76-P-104/77-P-046
Revised 9-8-77

APPLICATION NUMBER 77-P-046

STAFF REPORT

APPLICATION 76-P-104

Application 76-P-104
HIGH QUALITY VEGETATION
HIGHWAY NOISE IMPACT (70 dB(A) - $L_{10}$)
N
1" = 500'
BLAKE LANE
GERMANTOWN ROAD
BUSHMAN LANE
I-66

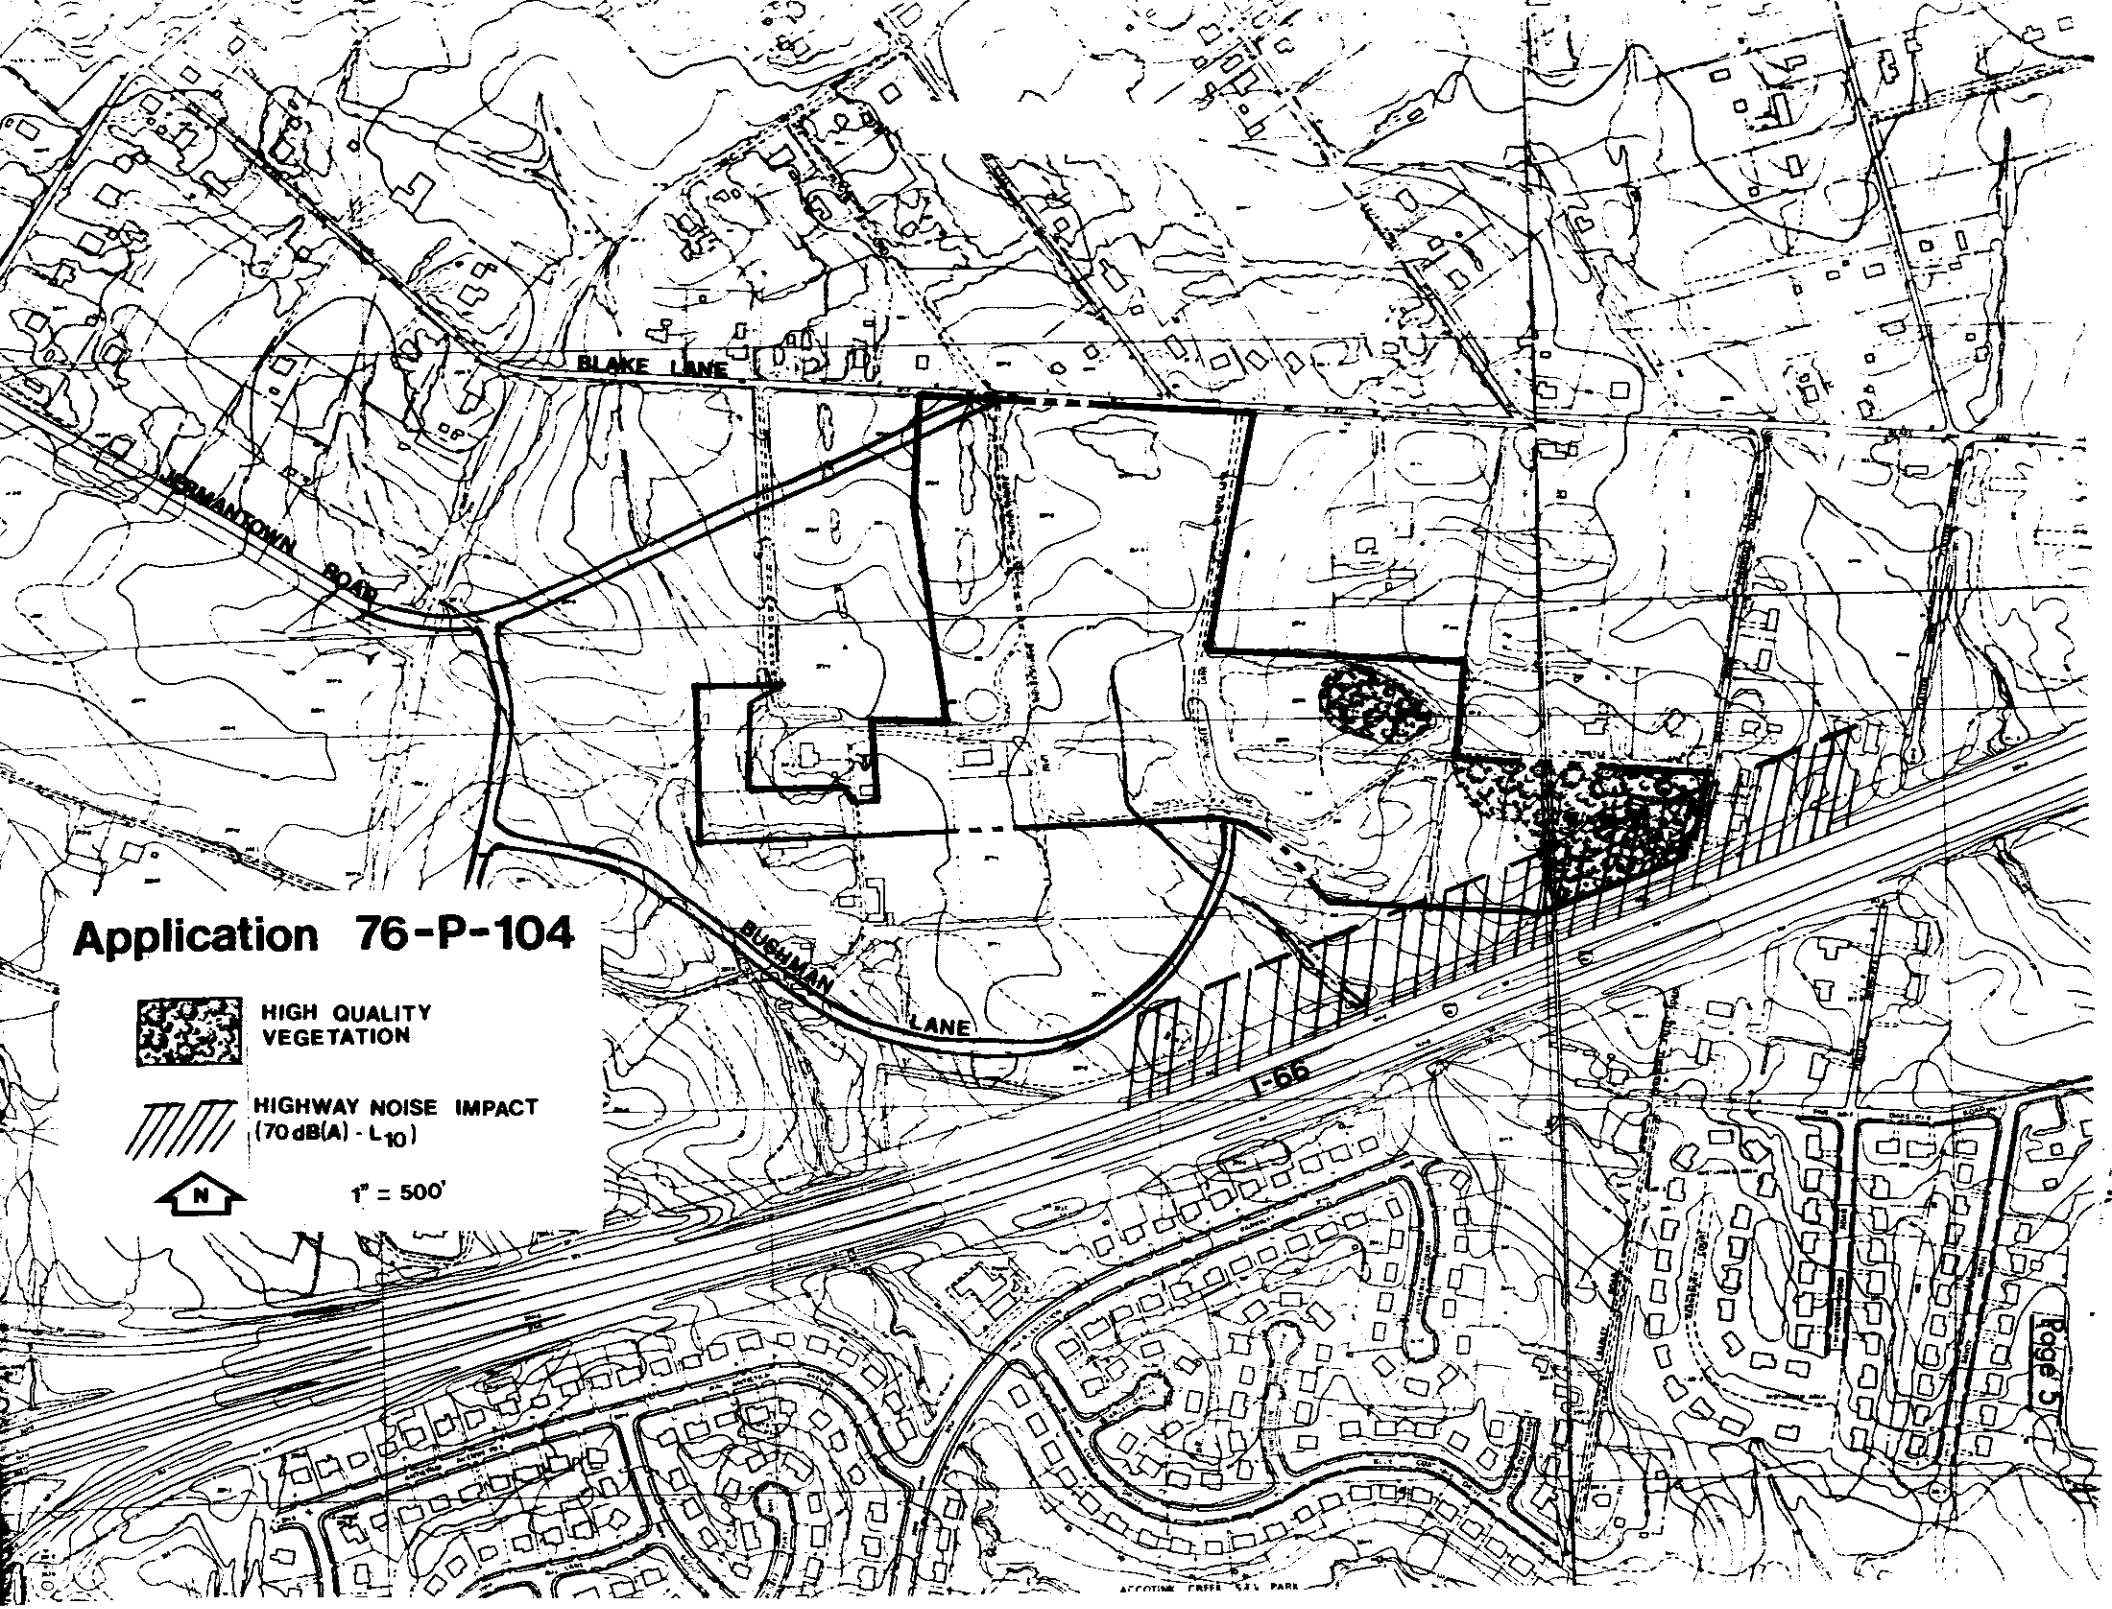
High quality vegetation, including monarch and/or specimen trees, has been duly and commendably noted on the proposed development plan, e.g., 40" dbh White Oak, 40" dbh Tulip Poplar, 38" dbh American Beech, etc. in the southeastern corner. (Also see Environmental Factors map for approximate location.) Although preservation of this vegetation may have only been implied by the development plan annotation, every attempt at preservation should be required and should be an essential consideration at time of site plan review. Notwithstanding grading requirements for construction of the garden apartment units, the present proposed layout appears to allow such preservation.

Almost without exception, the present layout shows units fronting on parking lots. Because of the nature of garden apartment design, approximately one-half of the residents will consequently have views of parking lots. Hence, in addition to any existing screening requirements, provisions should be made for additional screening of those parking lots which front on units and also act as thru roads.

Analysis of noise impact from I-66 indicates an impact zone 230' from centerline of the near lane or 145' into the site from the property line. Per HUD and FHWA guidelines, this impact zone represents areas unsuitable for residential use, especially those of a

The revised development plan has responded to this potential impact with several commendable design changes. First, garden apartment units within the noise zone have been deleted and replaced with either a parking facility or the retention of existing specimen vegetation. Second, even marginally impacted units have also been deleted and replaced at a greater distance from I-66 with a high rise apartment building focused at either end on site amenities (natural tree cluster and tennis court). Third, the visual focus from the apartment building towards I-66 has been centered on a retention pond between the parking facilities with a wooded vacant tract as a backdrop. This serves to break the parking lot "sea of osphalt" as well as enhance the visual perceptions from this part of the project. This is a substantial overall improvement in the project design.

- Develop the proposed detention ponds as open space amenities.
- Preserve the high quality vegetation in the southeastern portion of the property.
- Provide additional vegetative screening for parking lots along through streets on which apartment buildings front.
